Service Bulletin

SB-10042987-8678

SUBJECT: Special Coverage Adjustment - Shift Lever May Not Display Correct Gear

**MODELS: 2007-2008 Saturn AURA
Equipped with 4-Speed Automatic Transmission (ME7/MN5)**

1765068

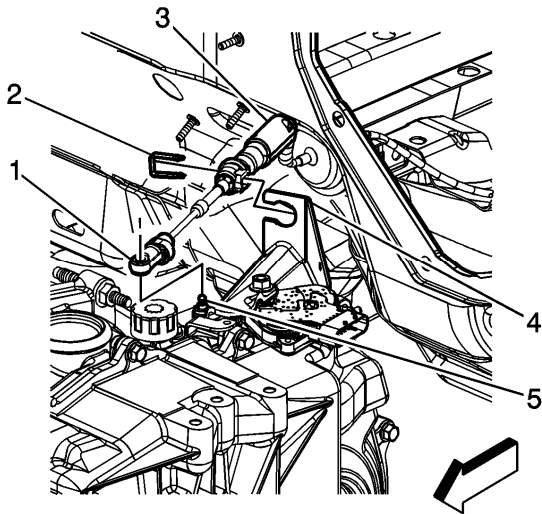
- Remove and discard the cable bracket (4).
- Install a new floor shift control cable and new bracket. Refer to *Floor Shift Control Cable Replacement* in SI
